Tractionel

Our ref. 73961B011
TE/NUPR/PD/DAN

Brussels, March 13th , 1984

As a representative of the belgian utilities to the Westinghouse Owners' Group , I have received a copy of your letter of November 15 , 1983 relating to the approach introduced in the Borselle reactor to cope with a SGTR accident.

FIG. 4 : WATER LEVEL IN PRESSURIZER (LRCA/PR11)

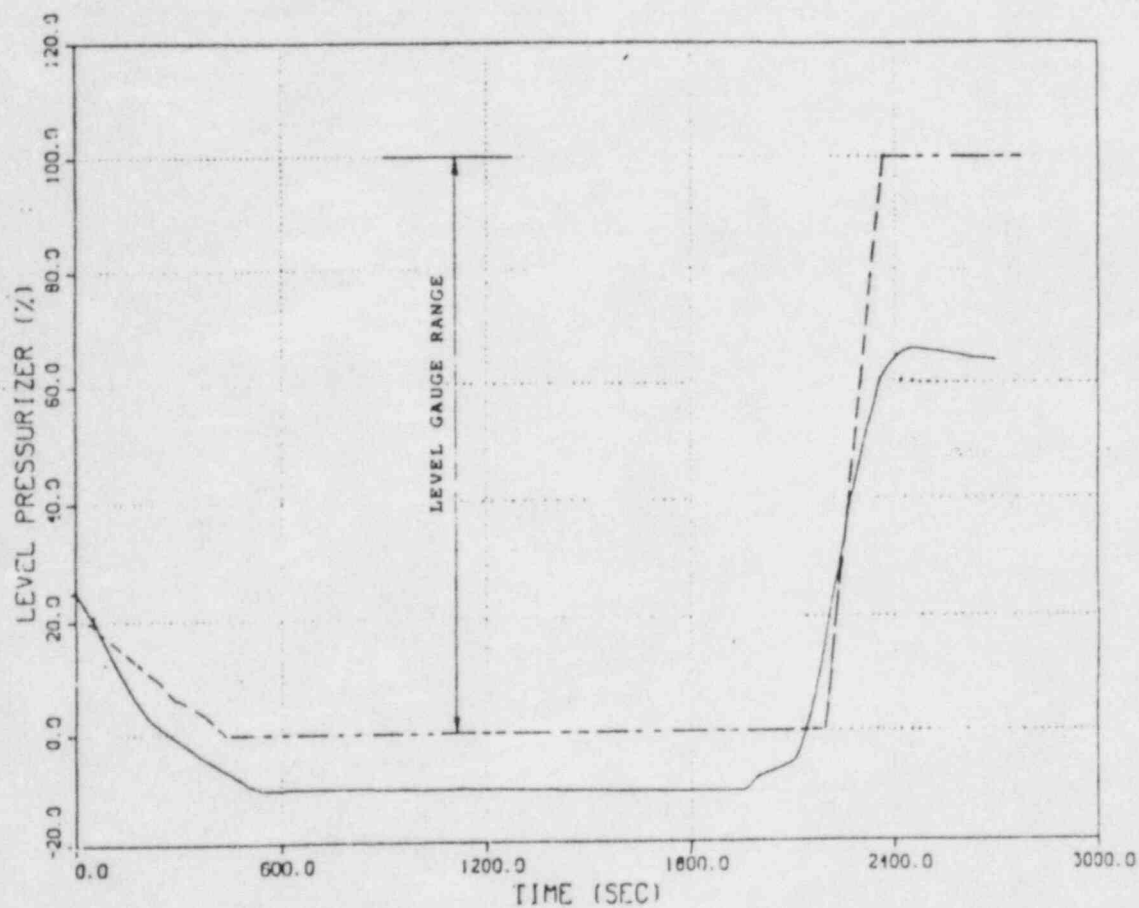
. In our plants , 'for many small break loca transients the application of a low pressurizer level - low pressurizer pressure coincidence trip will hardly change anything. Because of the smaller pressurizer size , the low pressurizer level setpoint will be reached before the low pressurizer pressure setpoint for SI generation is reached (cf events in Ginna , Doel , ref paper by E. STUBBE and H. MICHIELS presented at the Jackson Wyoming conference Sept 83 , fig. 4 - attached).

. However , many reactor transients have identified unreliable level readings (cf Doel) , because the level signal derived from a ΔP cell is calibrated only for nominal water conditions (densities) and cannot be used when the pressurizer conditions deviate from nominal conditions during a transient (e.g. by filling up with cold HPSI water combined with spray).
